**Economic and Social Council**Distr.: General
8 August 2024

Economic Commission for Europe**Inland Transport Committee****World Forum for Harmonization of Vehicle Regulations****Working Party on Lighting and Light-Signalling****Ninety-first session**

Installation UN Regulations:**UN Regulation No. 48 (Installation of Lighting and Light-Signalling Devices)****Proposal for a Supplement to the 06, 07, 08 and 09 series of amendments to UN Regulation No. 48****Submitted by the expert from the International Automotive Lighting and Light-Signalling Expert Group***

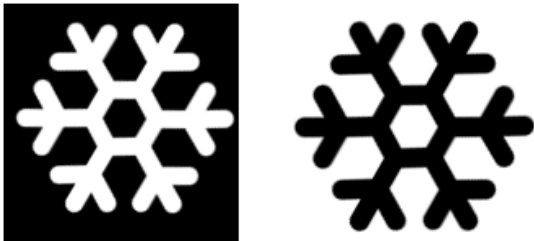
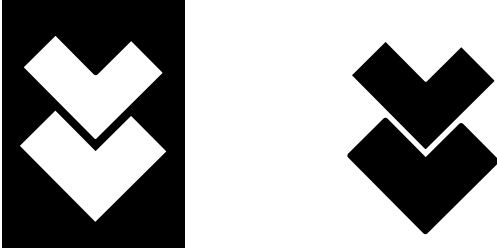
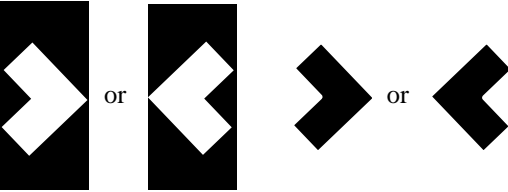
“5.35.12. Irrespective of the requirements of paragraph 5.35.11., for predicted trajectory illustrated in Annex 16:

5.35.12.1. The Driver Assistance Projection may be adapted according to the predicted trajectory of the centre of gravity of the vehicle. It shall not be wider than the width of the vehicle including any fitted accessories and trailer if applicable and, in any case, shall not be more than 2,600 mm.”

Wrong way warning	<p>Activated when the vehicle is entering a one-way road or a highway in opposite direction.</p> <p>Flashing at 4.0 hz +/- 1.0 hz allowed.</p>
	Lane keeping assist warning	Activated if the vehicle unintentionally exits its lane.
 <p>This figure is showing an example of the basic quadrilateral shape of the Driver Assistance Projection for predicted trajectory, as seen from the driver's perspective of a car in straight forward motion. The dashed lines are not part of the projection. They are a representation of the lines delineating the lane on which the vehicle is travelling, and only added to clarify the image and lateral boundaries of the predicted trajectory projection.</p>	Predicted trajectory	<p>This shape may change when adapted in conformity with the requirements in paragraph 5.35.12.</p>
